Subject: SQUEAKING NOISE FROM FRONT CONSOLE WHILE DRIVING ON ROUGH ROADS	Bulletin No: 09-048/16
	Last Issued: 08/12/2016

2016 CX-9 vehicles with VINs lower than JM3TC*****114514 (produced before July 18, 2016)

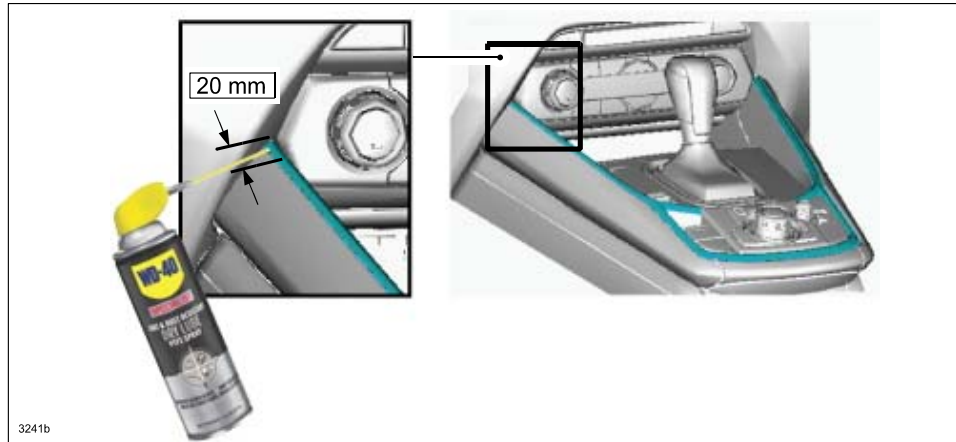
Some vehicles may exhibit a squeaking noise from the left and/or right side front console panels when driving on rough roads. The noise can also be reproduced by pushing the side panel at the location shown below.

The noise may be caused by the chrome decoration panel (A) interfering with the side panel (B). To eliminate the noise, a noise prevention tape has been added to the front console.

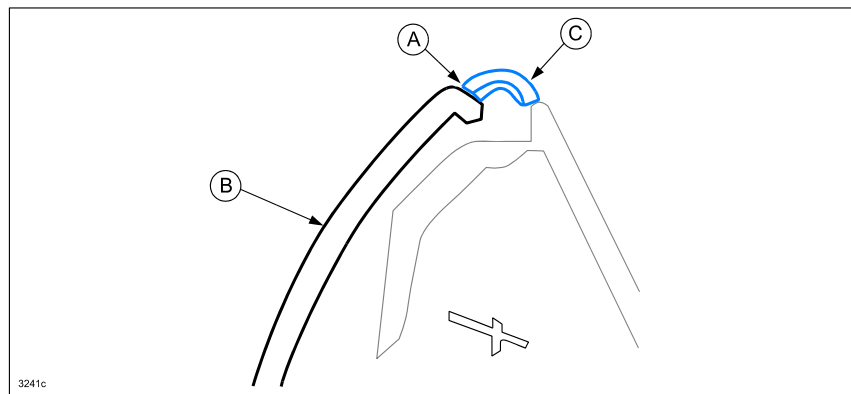
3. Apply lubricant (A) between the side panel (B) and the chrome decoration panel (C). Apply it to both the left and right sides.

CAUTION: Clean up the surface immediately after the lubricant is sprayed to avoid damaging the plastic.
